From: Ballard, Michael
Sent: Tuesday, July 2, 2024 10:13 AM
To: Chesler, Jeremy
Subject: RE: Wastewater Treatment System at 2800 S Pope Lick Rd

From: Chesler, Jeremy <jeremy.chesler@louisvilleky.gov>
Sent: Wednesday, June 26, 2024 2:15 PM
To: Ballard, Michael <Michael.Ballard@louisvilleky.gov>
Subject: Wastewater Treatment System at 2800 S Pope Lick Rd

RATLIFF RESIDENCE
 2800 SOUTH POPE LICK ROAD
 LOUISVILLE, KY 40299

SITE PLAN

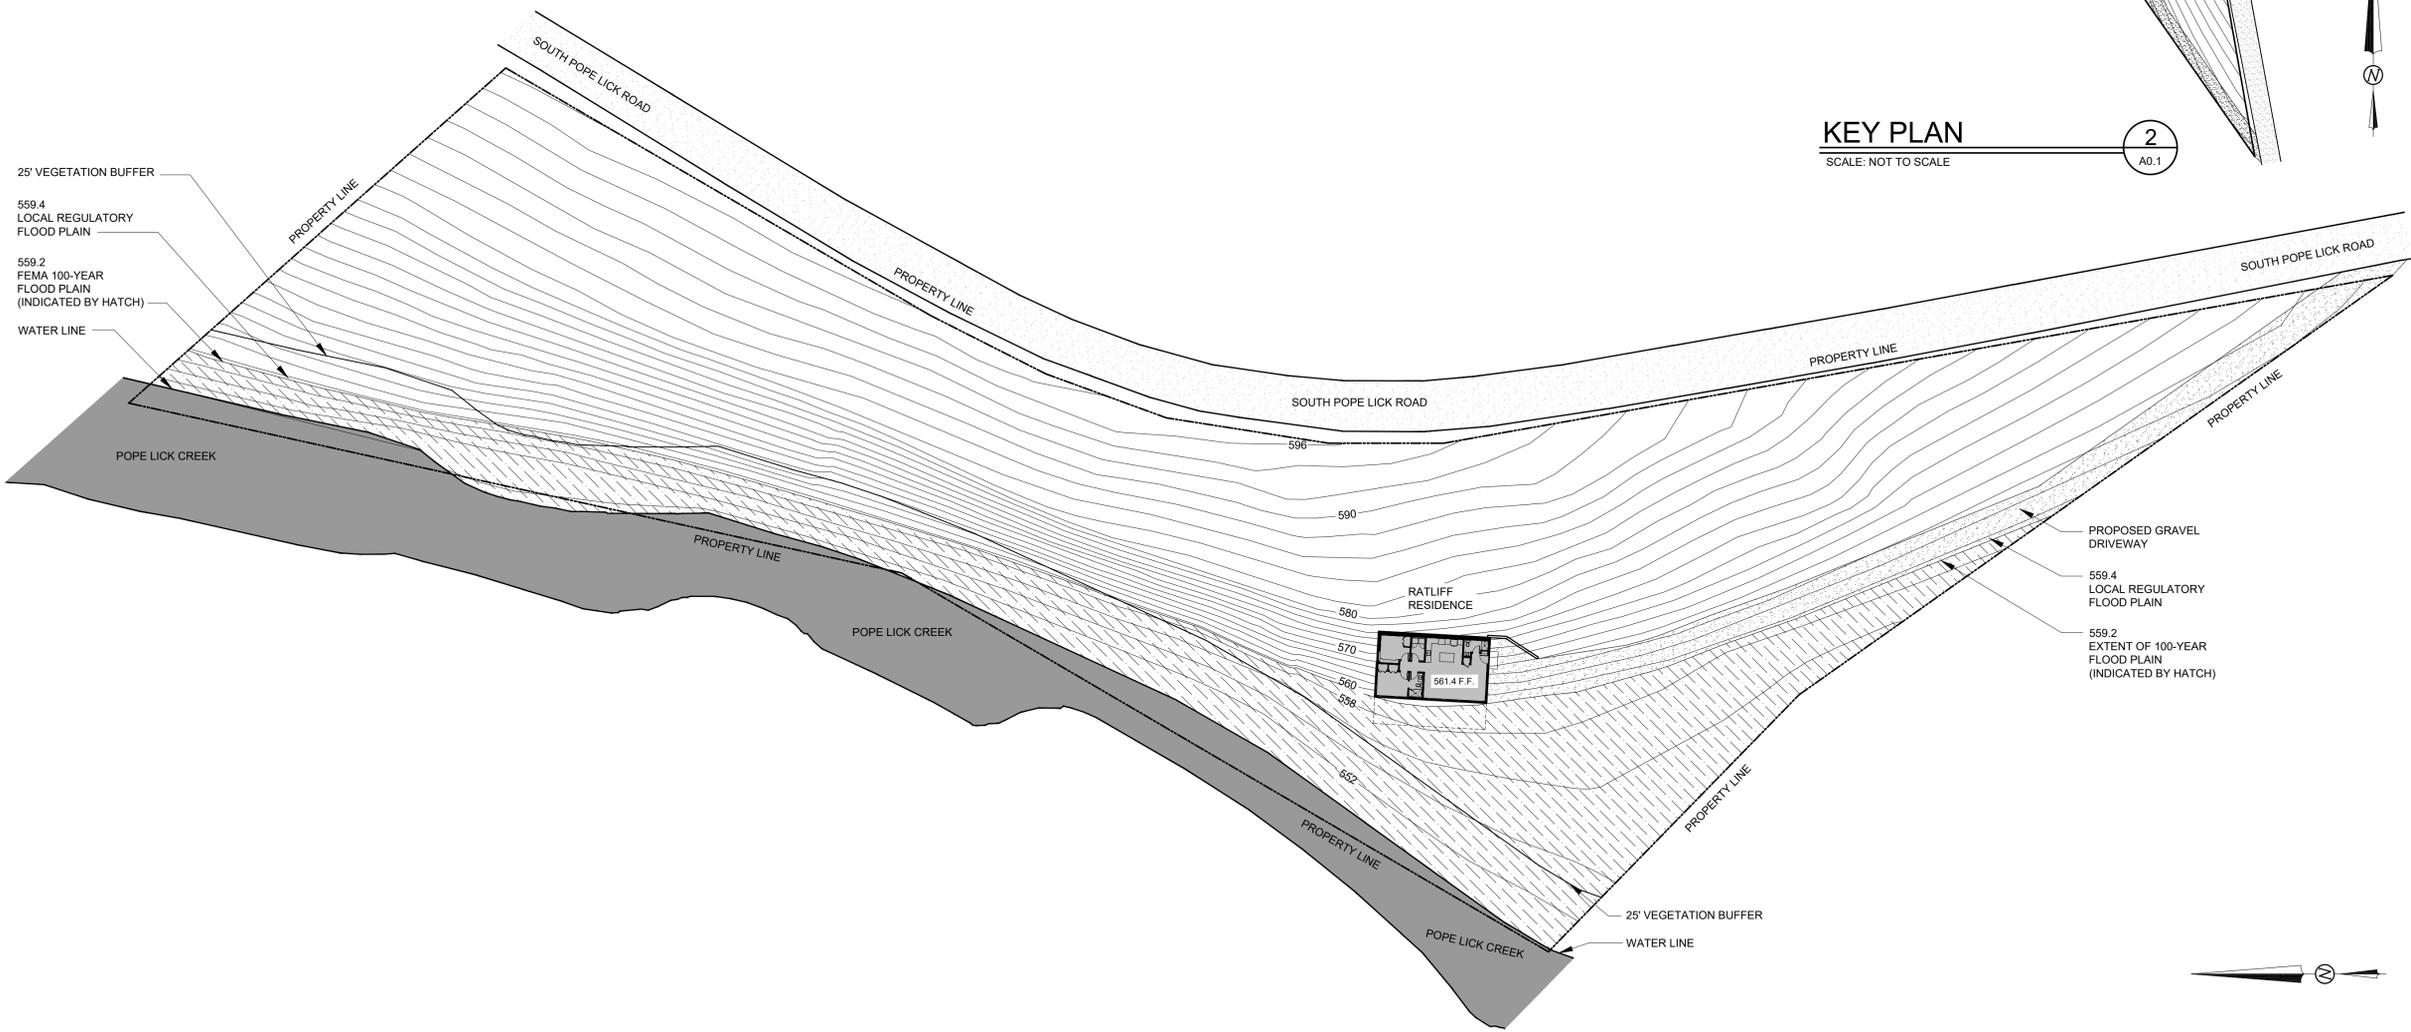
This request has come back up and the applicant is deciding to move forward with the variance request. The request is scheduled to be heard by the Board of Zoning Adjustment at a public hearing on Monday, July 15th. I am completing my review of the request and trying to get some additional input and confirmation about the Health Department's stance on what this applicant is proposing. I have attached a site plan that shows the precise location of the proposed on-site sewage disposal system. It appears that they will have a pipe discharging the treated effluent directly into Pope Lick Creek.

I was wondering if you can please review this site plan and verify whether or not the Health Department finds this proposal acceptable. If you have any comments or recommended changes, please let me know. Or if you find this proposal acceptable, a preliminary approval of what is being proposed would be appreciated.

Our office determined that a traditional sewage disposal system was not feasible for this proposed project... However, the applicant plans to get a permit for a sewage treatment system approved by the Kentucky Division of Water (we have no control over this type of system being approved and eventually installed)... not sure if they submitted to State yet... Is this in the Floyds Fork Corridor...
